Addendum / Addenda No./N° 4

| Project Description / Description de projet WIN - Fire Alarm Replacement Solicitation No./ No de sollicitation Project No./Nº de projet W.O. No./Nº d'ordre de travail WIN-A1-011387-01 Project Engineer / Ingénieur de projet L. Lalonde (204)896-1209 Notice: This addendum shall form part of the tender documents and all Cet addenda fait partie intégrale des dossiers d'appel d'offres; toutes les | | | | | |
|---|---|--------------------------|---|--------------------------------|--|
| Solicitation No./ No de sollicitation Project No./N ^o de projet W.O. No./N ^o d'ordre de travail 17-22017 WIN-A1-011387-01 Project Engineer / Ingénieur de projet Date L. Lalonde (204)896-1209 June 23, 2017 Notice: Nota: | Project Description / Description de projet | | | | |
| Solicitation No./ No de sollicitation Project No./N ^o de projet W.O. No./N ^o d'ordre de travail WIN-A1-011387-01 Project Engineer / Ingénieur de projet L. Lalonde (204)896-1209 Notice: Nota: | WIN - Fire Alarm Replacement | | | | |

ADDENDUM

Figure 1

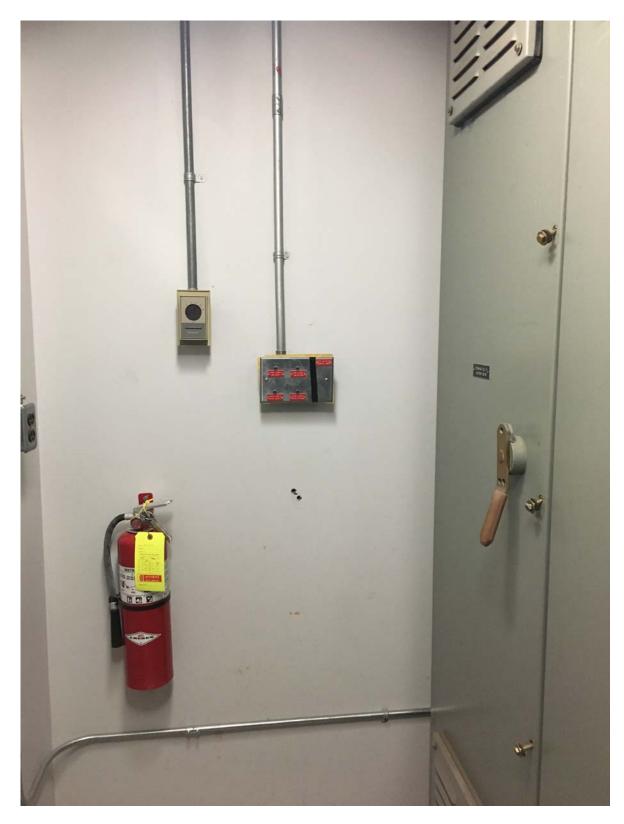
Q: Are duct smoke remote annunciating panels required in the new installation?

A: All existing duct smoke remote annunciating panels shall be demolished. These are not required in the new installation as all detection is addressable. Typical of mechanical spaces, refer to attached photo (Figure 1).
